**GOVERNMENT OF THE DISTRICT OF COLUMBIA
DEPARTMENT OF CONSUMER AND REGULATORY AFFAIRS
OFFICE OF THE ZONING ADMINISTRATOR**

Re: 200 K Street, N.W.

We reviewed certain changes to the plans, to determine whether what you have proposed is consistent with the plans approved by the Commission and the flexibility afforded under the Regulations and the Orders. The plans as approved and the proposed plans are attached.

A1.02a

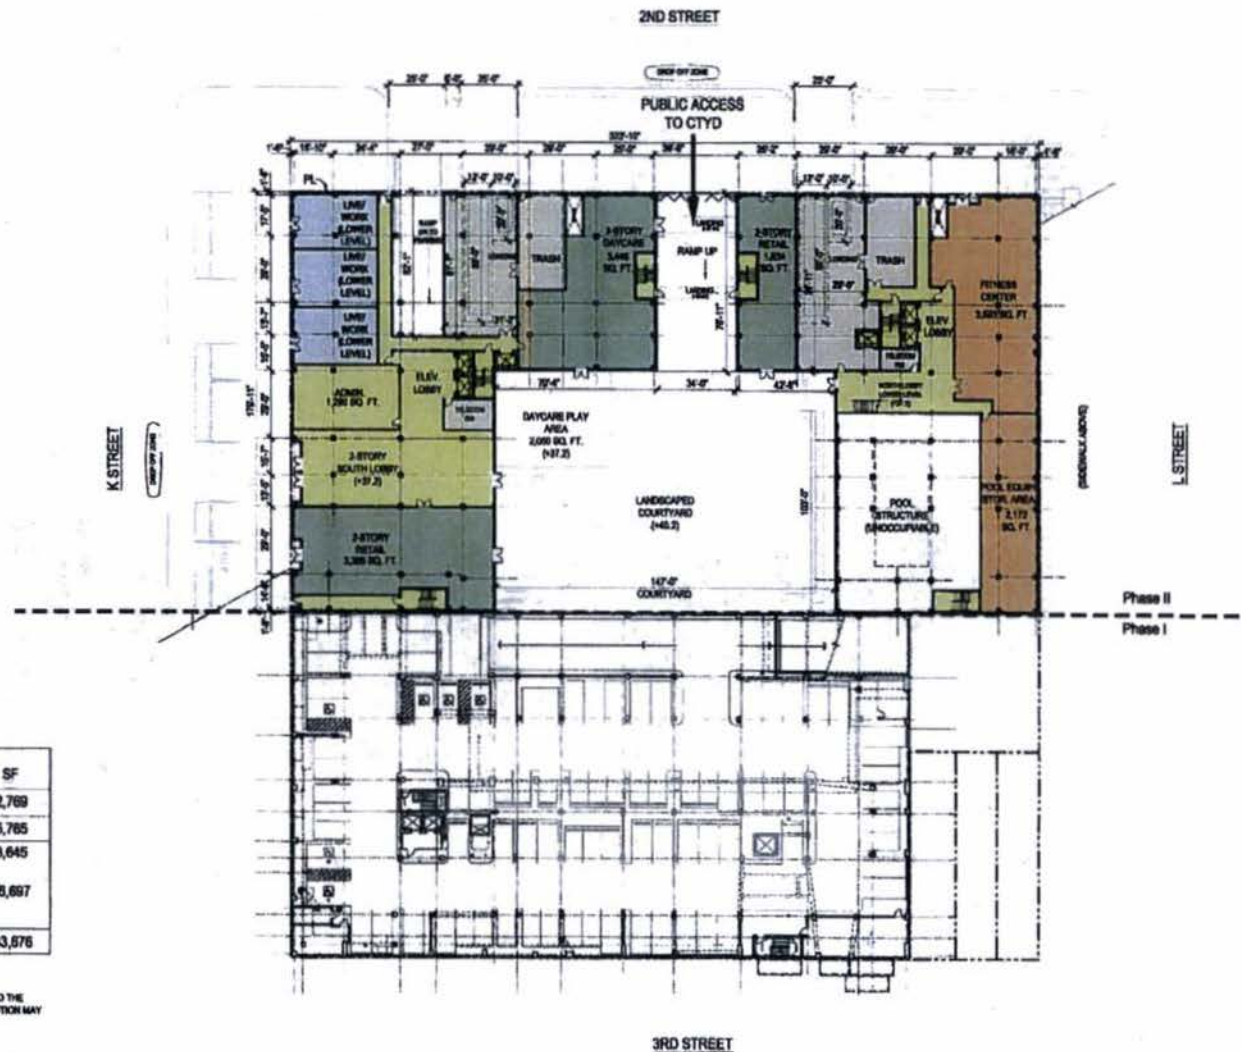
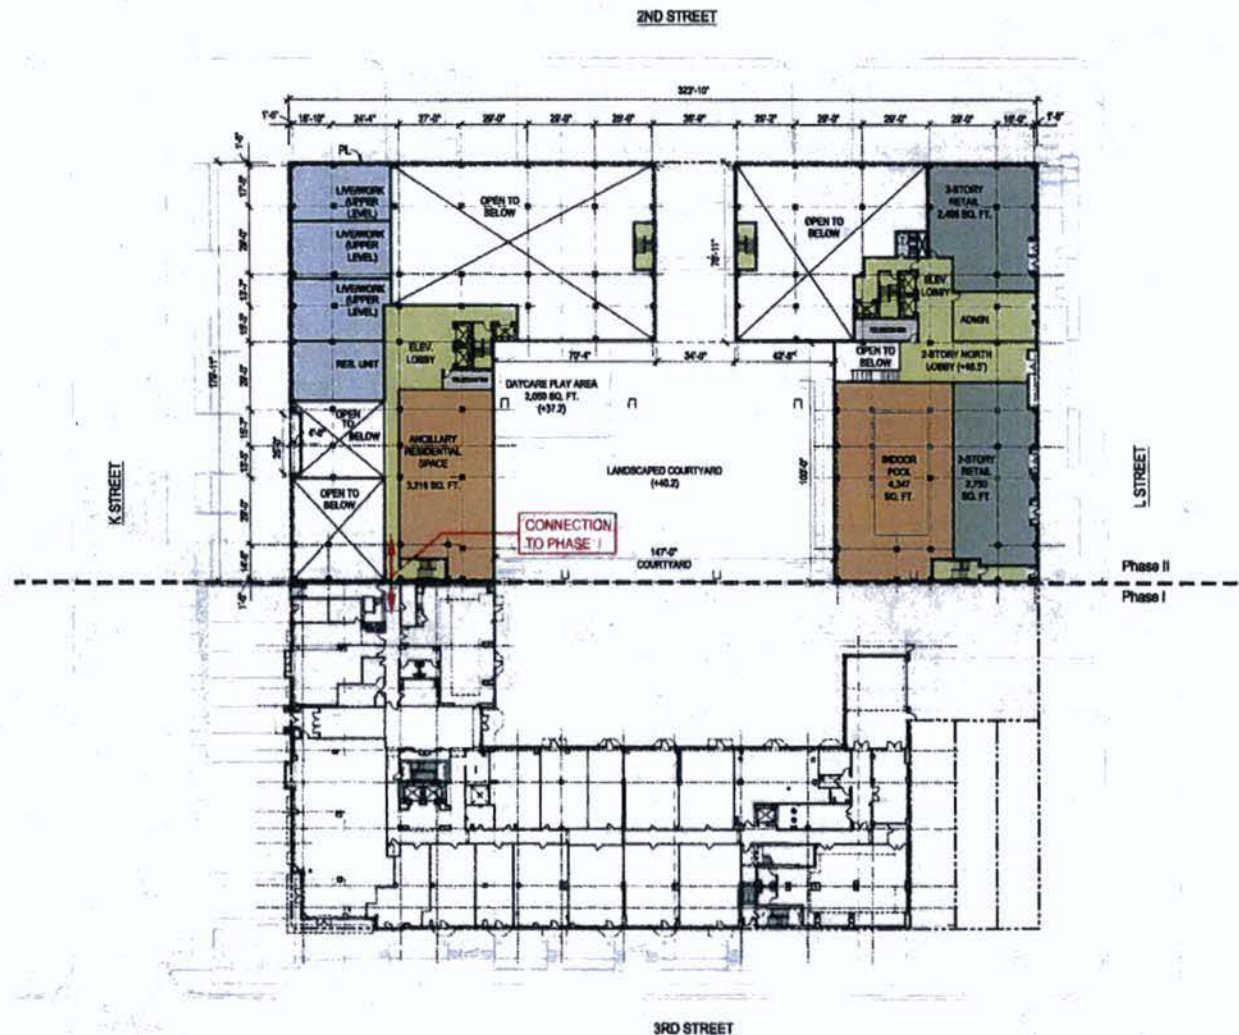
- The approved access to the parking garage for the 200 K Street building is shown on Sheet A1.02a as a ramp from 2nd Street. The approved location of the loading berth is also on 2nd Street immediately north of the parking garage entrance. The vehicular access area is comprised of two 25 foot curb cuts with a 6 foot safety island in the between. The proposed plan, shown on the First Floor Plan, dated December 5, 2012, would "flip" the location of the parking ramp and the loading berth, with the same total width of the access area. The exterior façade, which had the appearance of two separate garage doors, will look the same. This is consistent with the flexibility granted in Condition No. 1a of Order No. 05-36A, which allows the applicant to "vary the location and design of all interior components ... provided that the variations do not change the exterior configuration of the building."

- The approved first floor plan shows three live-work units at the southwest corner of the building and shows an indoor pool and related pool storage on the northeast corner of the building. The proposed first floor plan replaces the pool with additional residential units and replaces the live-work units with ancillary residential space, which will include lounges, meeting rooms, recreation rooms and other services for the residents. The approved second floor plan, Sheet A1.03a, shows the upper level of the pool area and the upper level of the live-work units. The proposed second floor plan inserts four units in place of the pool and three regular units in place of the three live-work units, where the open area above the pool existed and where the 2nd floor of the live-work units existed respectively, for a net increase of four units. The proposed third floor plan inserts four units in place of pool where the open upper level above the pool existed. These and other interior changes to the floor plans result in the total number of units proposed for the 200 K Street building ranging between 500 and 525 units, and increased the gross floor area of the building by approximately 7,304 square feet, as permitted by the flexibility granted in Condition No. 1e of Order No. 05-36A and for the increased FAR pursuant to Section 2409. The interior rearrangement is consistent with the flexibility granted in Condition No. 1a of Order No. 05-36A, cited above.

A1.03a

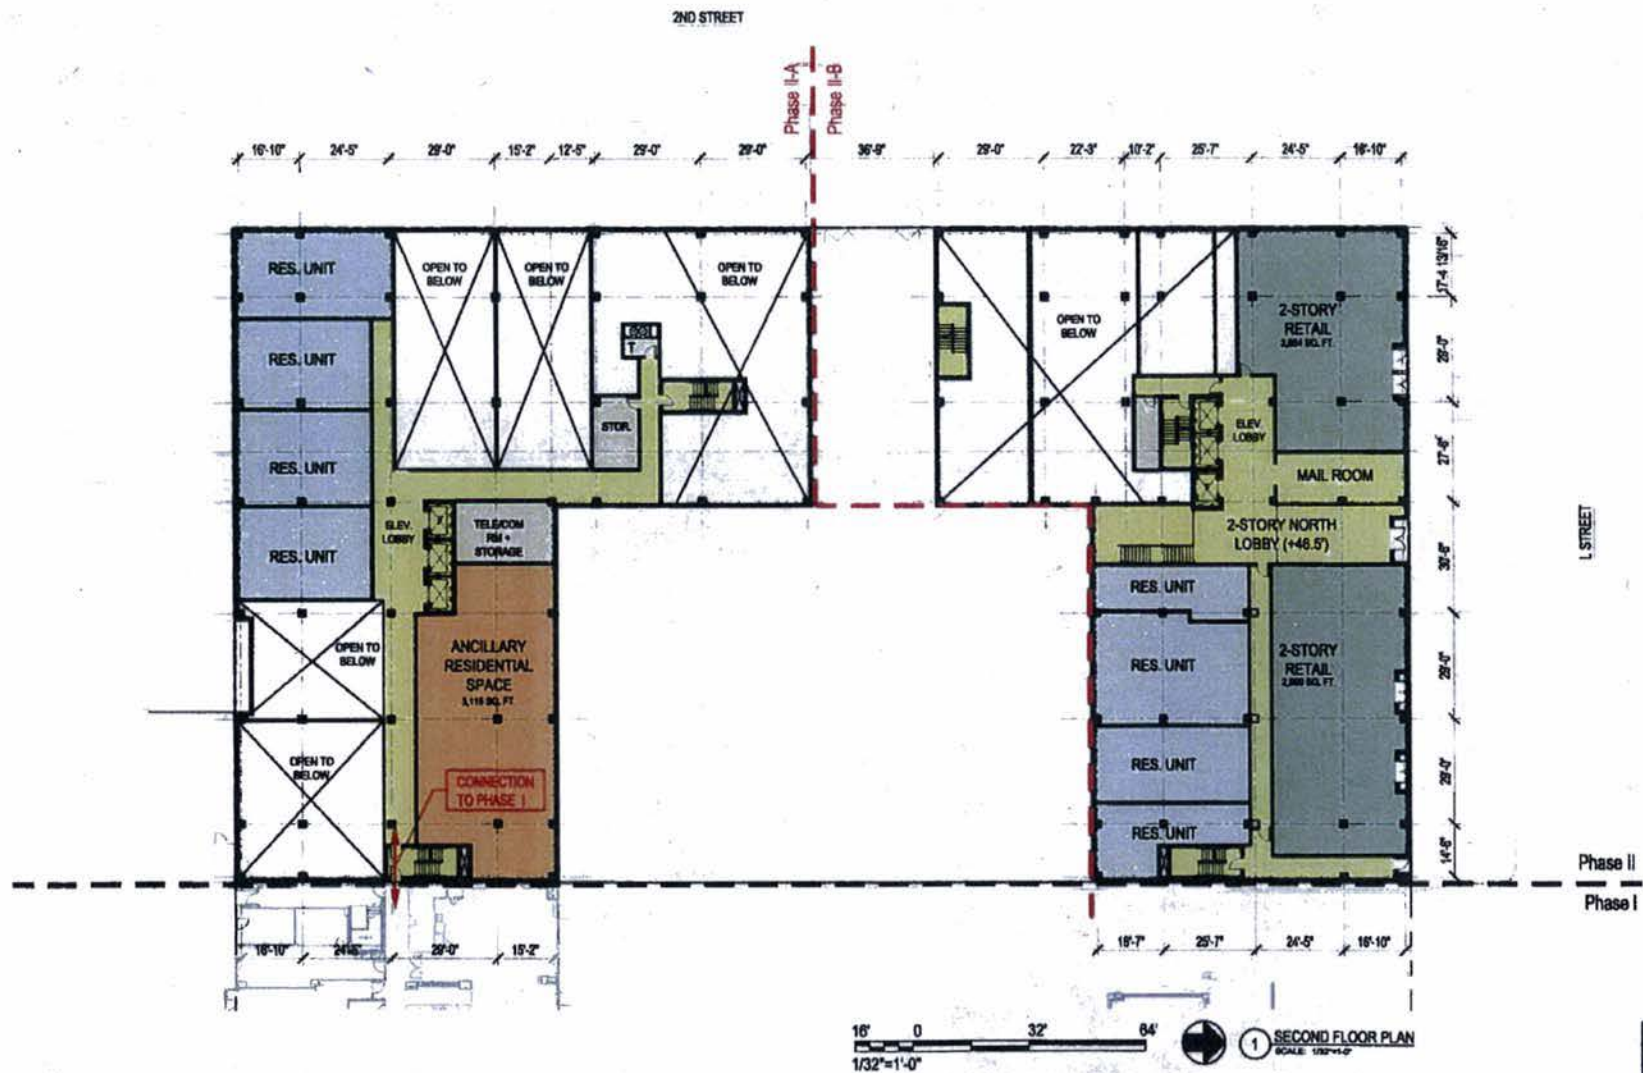
- The 200 K Street and 250 K Street buildings were connected through a common hallway and stairwell at the second, third and fourth floors, as shown on Sheets A1.03a, A1.04a and A1.05a. Under the proposed Second Floor Plan, dated December 5, 2012, there would be an interior connection only at the second floor level and arranged so that both buildings would have a corridor leading into a common stairwell. The interior rearrangement is consistent with the flexibility granted in Condition No. 1a of Order No. 05-36A, cited above.
